Planning Commission

August 22nd, 2018

APPLICATION FOR SITE PLAN APPROVAL
FOR 1651 TIFFIN AVENUE AND 2513 VENICE
RD.

APPLICATION FOR SITE PLAN APPROVAL
FOR 1800 CLEVELAND ROAD

THE FOREST SANDUSKY – Landscape Plan

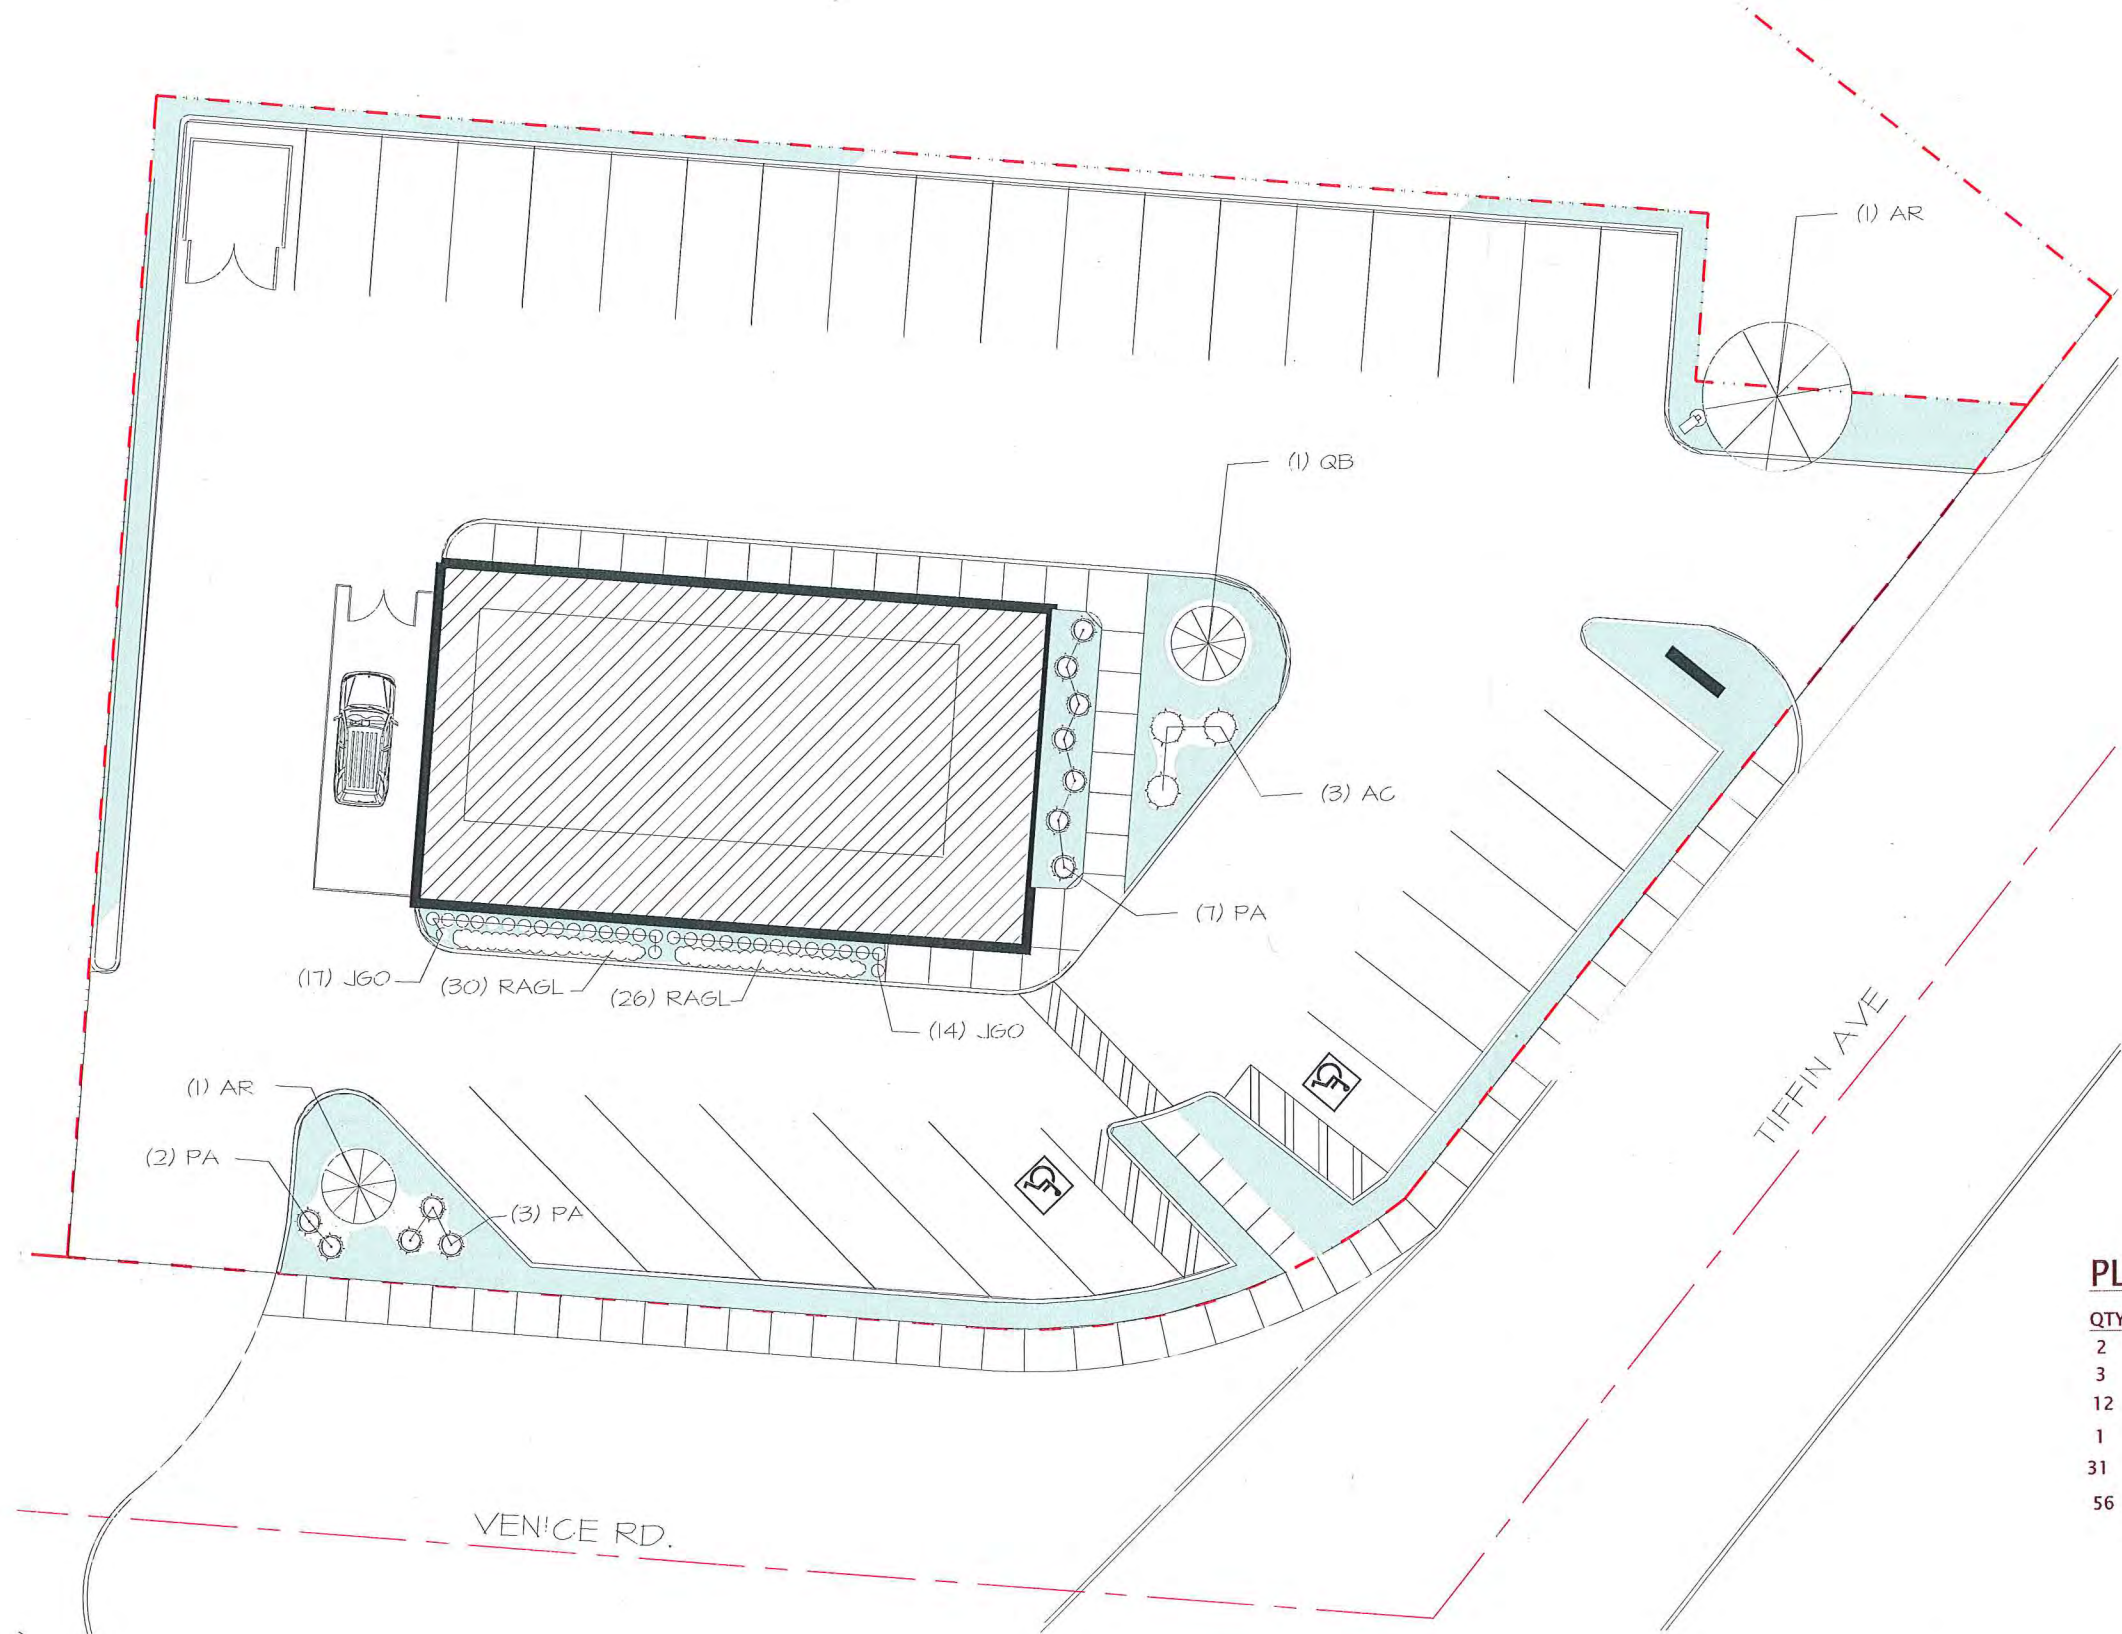
Staff has communicated with the applicant that further landscaping should be included within the buffer area between the parking lot and sidewalk. Section 1149.09 (b) requires that landscaping that is immediately adjacent and parallel to streets and sidewalks include a combination of hardy canopy trees, shrubbery and ground cover. Further details of required landscaping are provided later in that section.

1. All lot split/combinations are approved prior to construction.
2. The applicant provides further landscaping between sidewalk parking areas.
3. Revise landscaping plan for staff approval per section 1149.09 (b)
4. Signage shall be through a separate permit
5. The applicant works with the City of Sandusky Engineer to provide sidewalks to City specifications.
6. Applicant provides a revised plan showing location of directional signage for the site.

Cedar Fair
Entertainment Company
CEDAR POINT H.R. CENTER
SITE AND DIMENSION PLAN
WARD 2, CITY OF SANDUSKY, ERIE COUNTY, OHIO

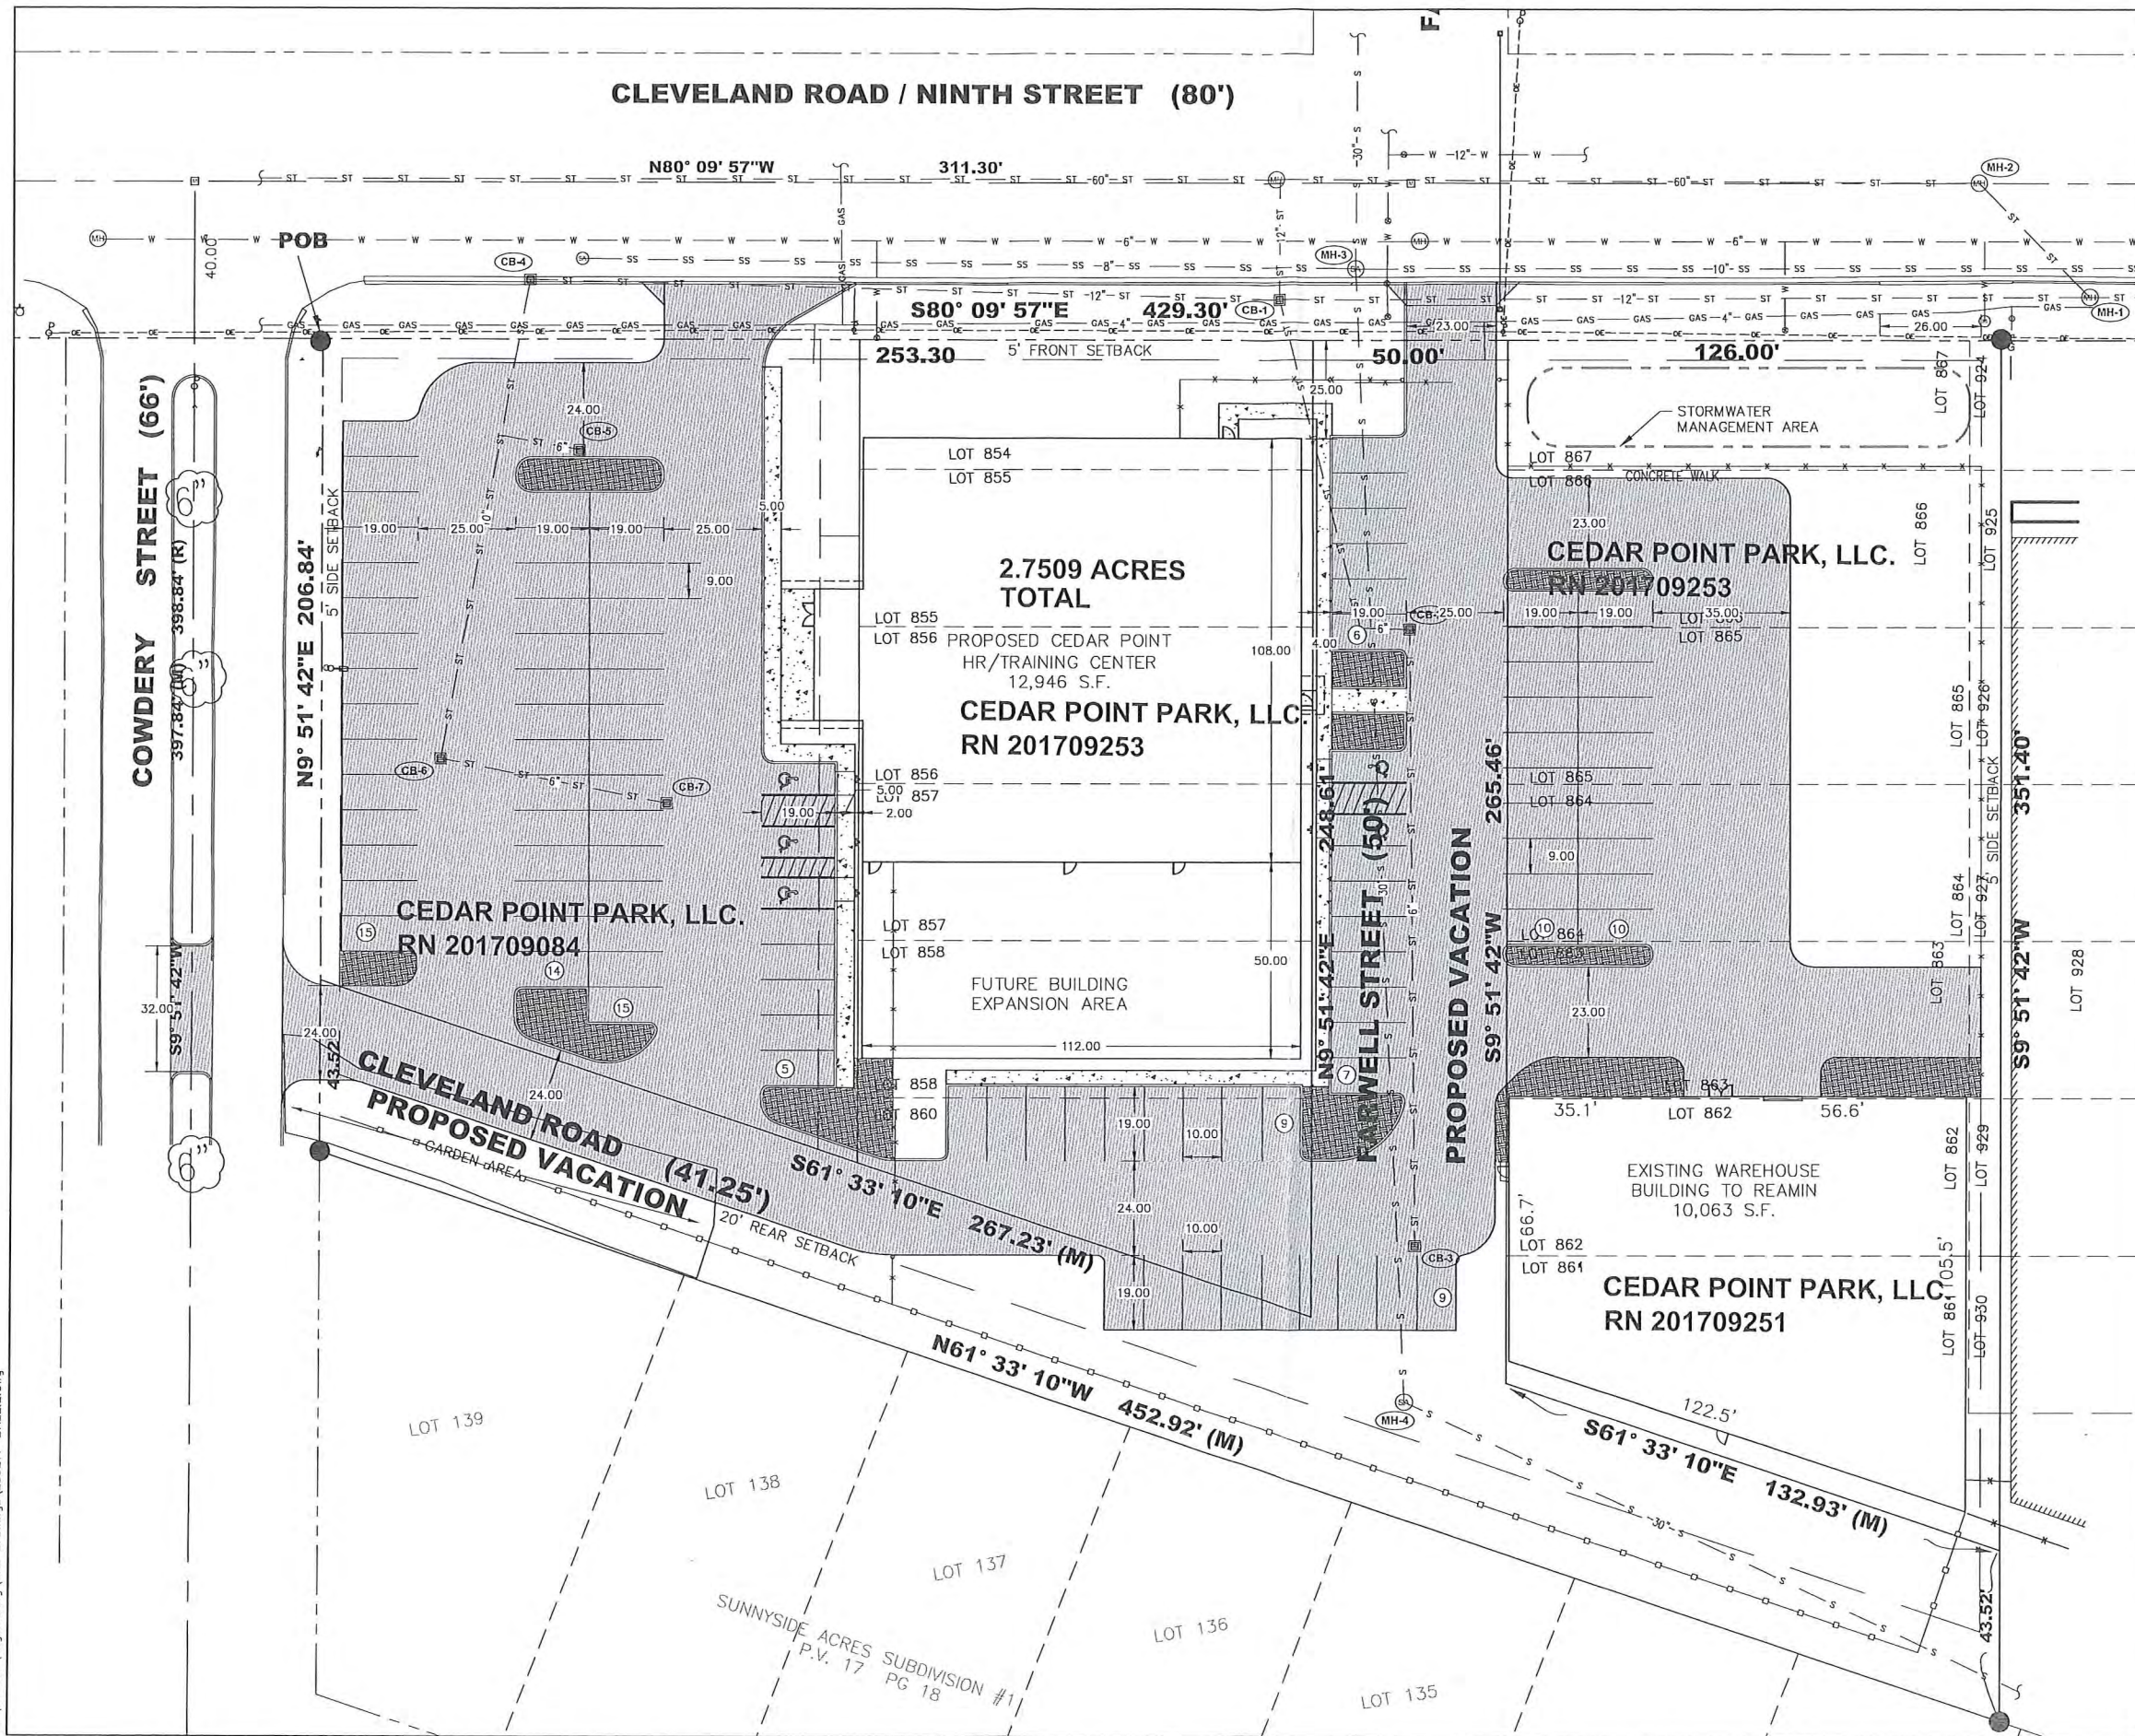
Staff recognizes that many of the individuals occupying these facilities do not arrive by car, as such we believe the parking will be more than sufficient and consideration should be taken for other modes of transportation to the site. As such we believe that sidewalks should be installed along both Cowdery Street and Cleveland Road. As seen in the engineers comments, they also would like the site plan to take into account how bus transportation would flow through the site.

The site plan provided did not indicate any landscaping for the site. Section 1149.09 references landscaping along surface area parking lots, the applicant has stated that they do intend to include landscaping in the future.

Section 1149.10 states that parking areas shall be adequately illuminated whenever necessary to protect the public safety. Illumination shall also be designed and located that light sources are shielded from adjoining residential districts and streets. The applicant has stated that they intend to provide lighting details to staff.

1. Storm water management needs to be discussed and reviewed prior to engineering approval
2. Lighting plan is needed
3. How will bus traffic flow onto-off site? Auto turn path is requested.
4. Underground utilities through current rights of ways will require setbacks and easements for work to be performed in case of emergency.
5. Request sidewalks, handicap curb ramps and concrete aprons.

1. The appropriate alleys are vacated and proper setbacks are maintained.
2. Sidewalks are included with the construction for the site to City of Sandusky Engineer specifications.
3. Staff approval of the landscaping plan
4. Staff approval of the lighting plan
5. All building and zoning permits are to be obtained.
6. All state and federal laws shall be observed.
